UNITED STATES
DEPARTMENT OF THE INTERIOR
BUREAU OF LAND MANAGEMENT

SUNDRY NOTICES AND REPORTS ON WELLS

1 Type of Well <input checked="" type="checkbox"/> Oil Well <input type="checkbox"/> Gas Well <input type="checkbox"/> Other	5 Lease Serial No NM 14847
2 Name of Operator CIMAREX ENERGY CO. OF COLORADO ATTN: ZENO FARRIS	6. If Indian, Allottee or Tribe Name
3a Address 5215 N. O'CONNOR BLVD., STE. 1500, IRVING, TX 75039	7 If Unit or CA/Agreement, Name and/or No
3b Phone No (include area code) 972.443.6489	8 Well Name and No MUSKEGON 17 #2
4 Location of Well (Footage, Sec, T, R, M, or Survey Description) UNIT LETTER P 660' FSL & 660' FEL SECTION 17, T-17S, R-29E	9. API Well No 30-015-34283
	10. Field and Pool, or Exploratory Area EMPIRE; ABO
	11. County or Parish, State EDDY NM

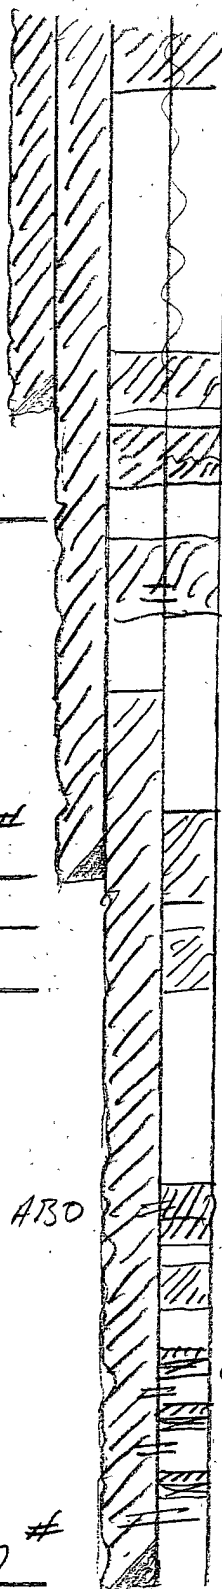
Add plug from 10000-9800 (25 SX min.)
35 7290-6990

6990 WOC Tag (ALO & WOC Tops)
7290 300' plug
4800
10000 200' plug strown

- 1) MIX & PUMP A 25 SX. CMT. PLUG @ 7,000'-6,800'; WOC & TAG TOP OF CMT. PLUG; CIRC. WELL W/ PXA MUD.
- 2) MIX & PUMP A 25 SX. CMT. PLUG @ 5,425'-5,225'.
- 3) MIX & PUMP A 25 SX. CMT. PLUG @ 4,615'-4,415' (9-5/8" CSG. SHOE); WOC & TAG TOP OF CMT. PLUG.
- 4) MIX & PUMP A 25 SX. CMT. PLUG @ 2,305'-2,105' (T/S.A.) Part @ 2305 Sg. adequate to fill 200' WOC TAG
- 4) ATTEMPT TO CUT & PULL BAD (POSSIBLY PARTED) CSG. @ +/-500'-700'.
- 5) MIX & PUMP A 50 SX. CMT. IN/OUT PLUG @ CSG. CUT (STUB PLUG); WOC & TAG TOP OF CMT. PLUG.
- 6) MIX & PUMP A 50 SX. CMT. PLUG @ 305'-205' (13-3/8" CSG. SHOE); WOC & TAG TOP OF CMT. PLUG.
- 7) MIX & PUMP A 15 SX. CMT. SURF. PLUG @ 65'-3'.
- 8) DIG OUT & CUT OFF WELLHEAD 3' B.G.L. & WELD ON STEEL PLATE & DRY HOLE MARKER.
